有關渠務署對 A/YL-KTN/967 的查詢

收悉 貴署對 A/YL-KTN/967 申請的意見，現以 R to C 形式書面回覆。

Proposed
Drainage Plan
擬議渠務建議

臨時動物寄養所連附屬設施 (為期3年)
及填土
Temporary Animal Boarding Establishment
with Ancillary Facilities
For a Period of 3 Years and Filling of Land

Appendix 5

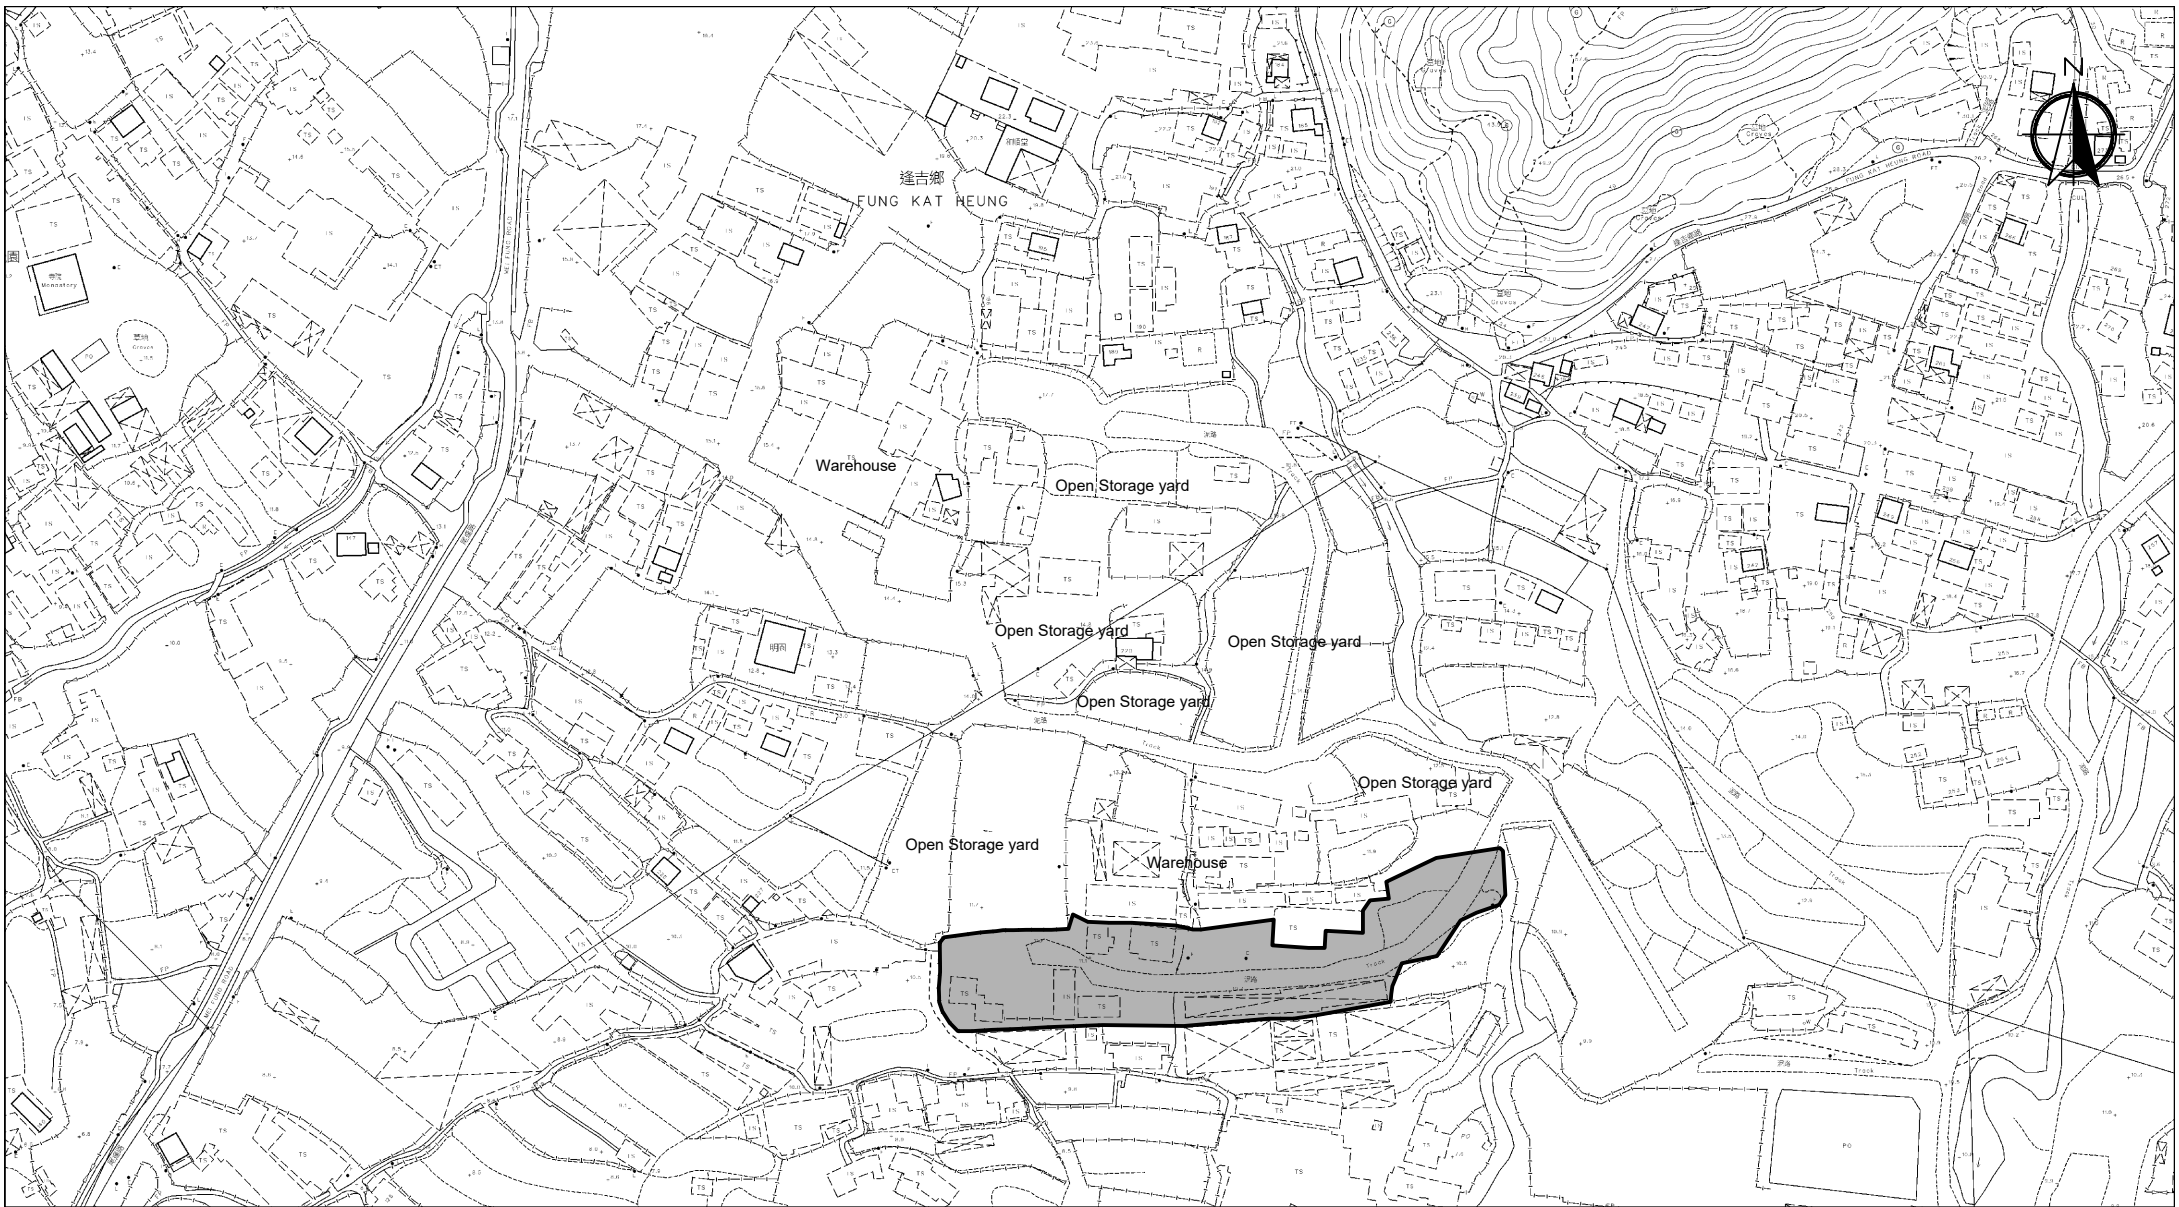
(h)	Please advise the distance between each catchpit and justify the levels are fulfilled the proposed 1 in 200 gradients. Please critically review the invert levels.	已依照 貴署的意見更改。請參考 Appendix 5。

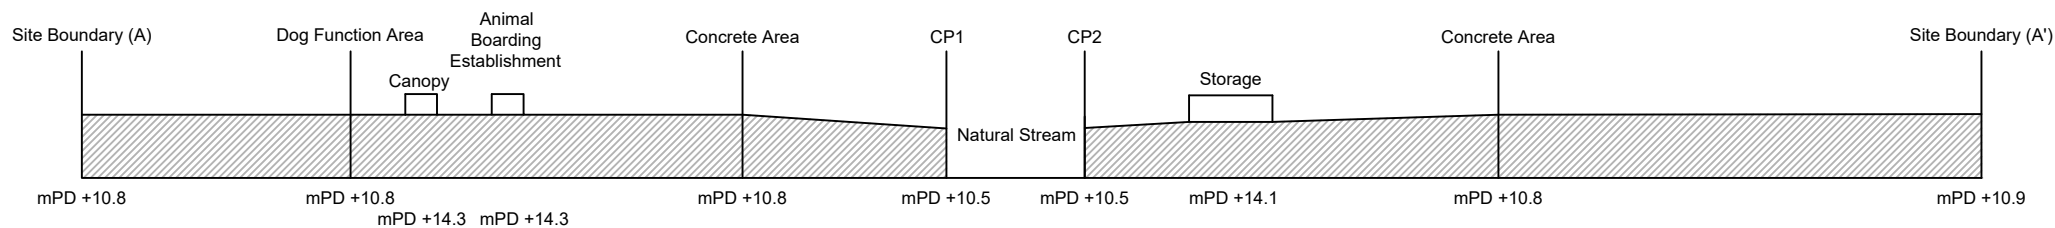
(e)	Please advise why u-channel is not provided at the northern side of the site. Please advise how the overland flow from the above area of the site could be properly intercepted and discharged. Peripheral surface channels shall be provided along the site boundary to collect the surface runoff accrued on the application site and to intercept the overland flow from the adjacent lands.	由於申請地點的北面大多地方已發展，並已由其他土地的使用人興建圍牆及渠道。因此不會有流水流到本申請範圍內。請參考 Appendix 5.1、5.3 及文件尾端。

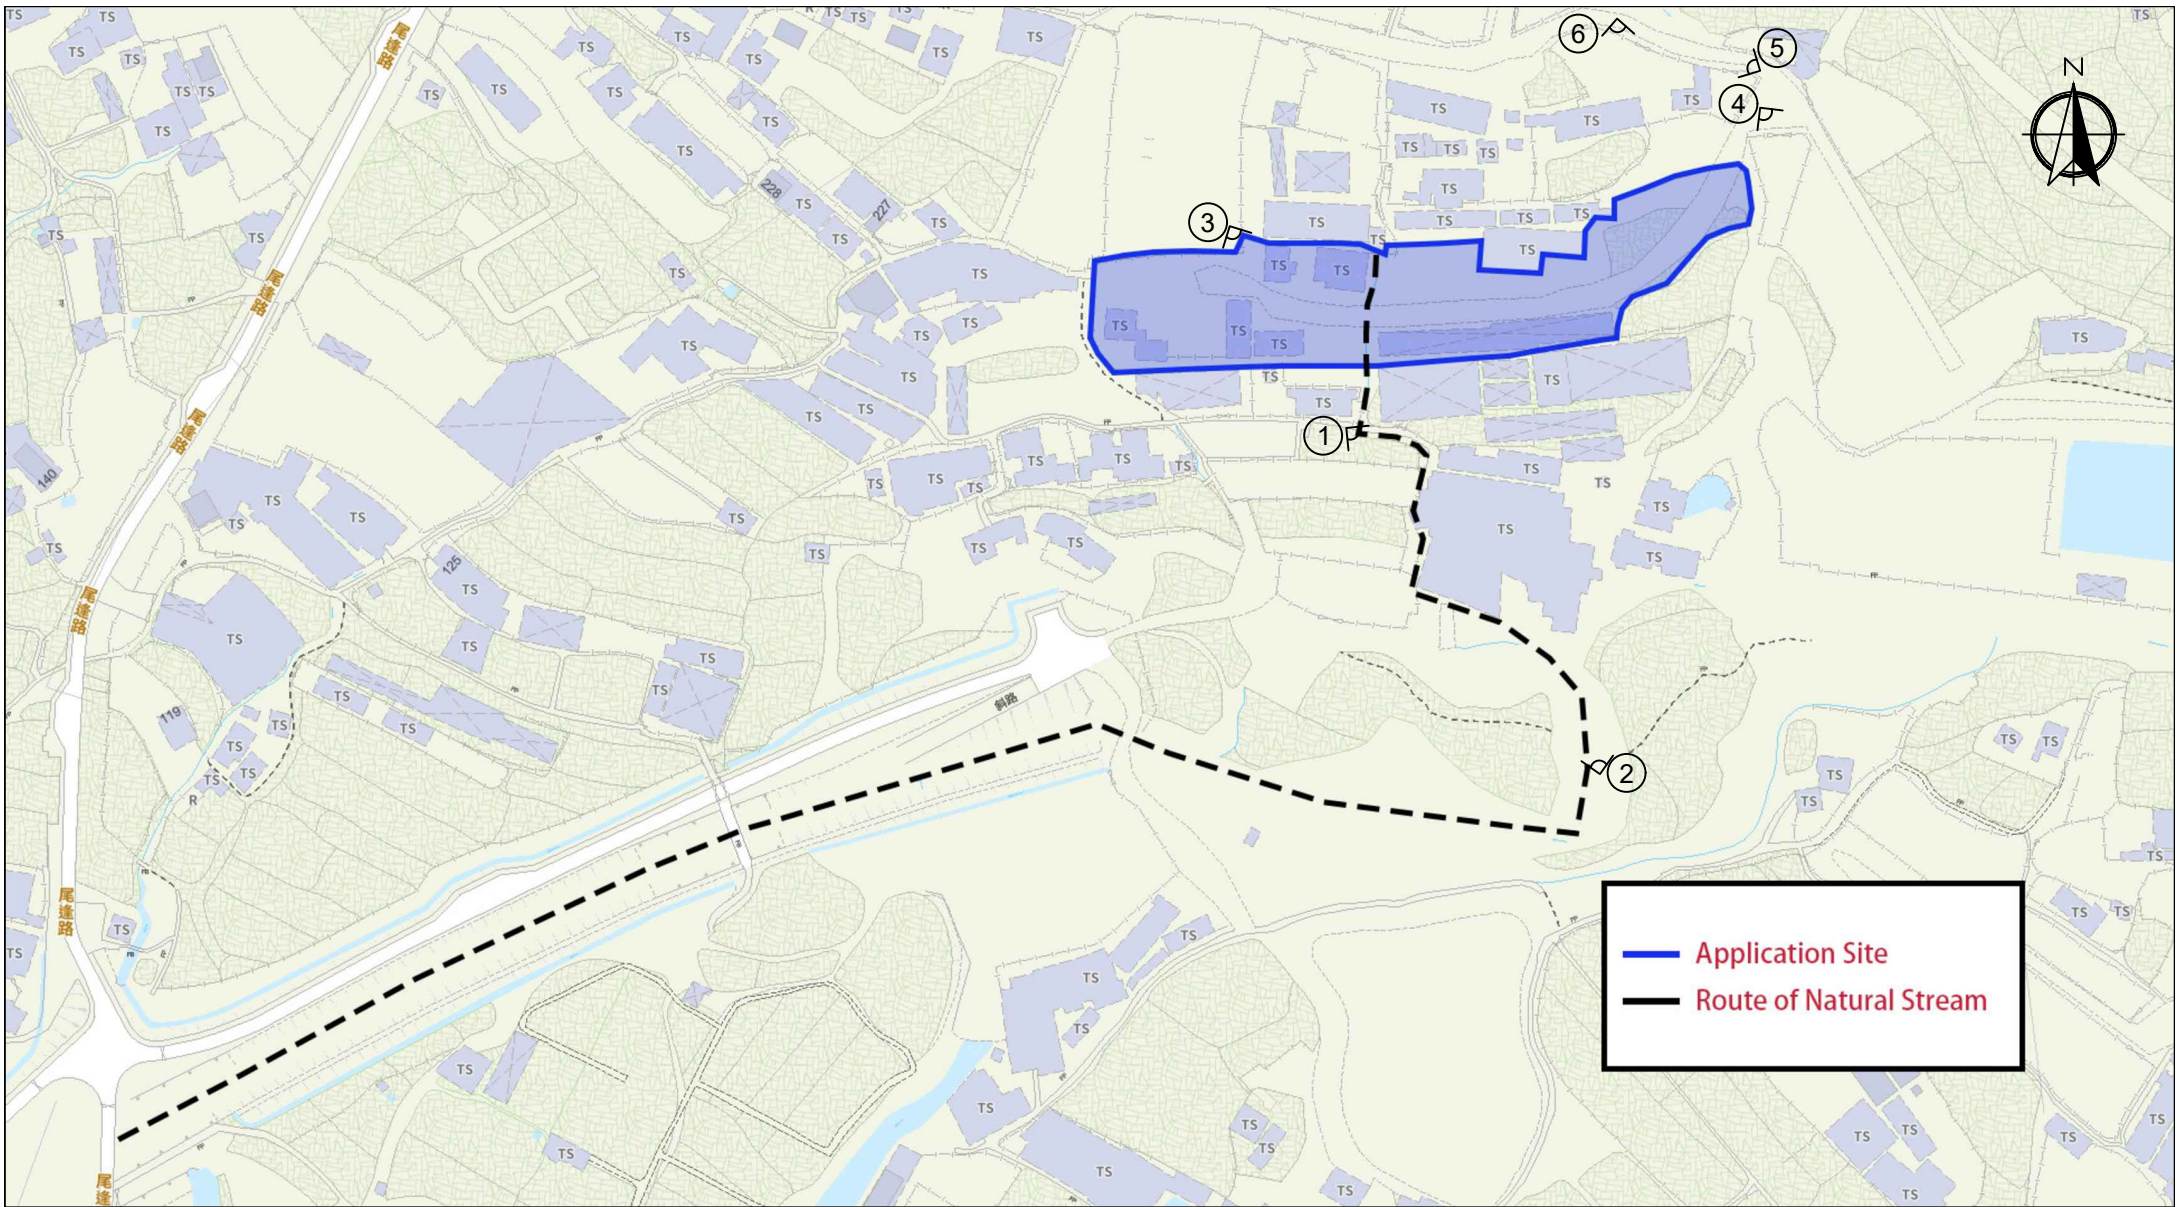
(m)	Cross sections showing the existing and proposed ground levels of the captioned site with respect to the adjacent areas should be given.	請參考 Appendix 5.2。
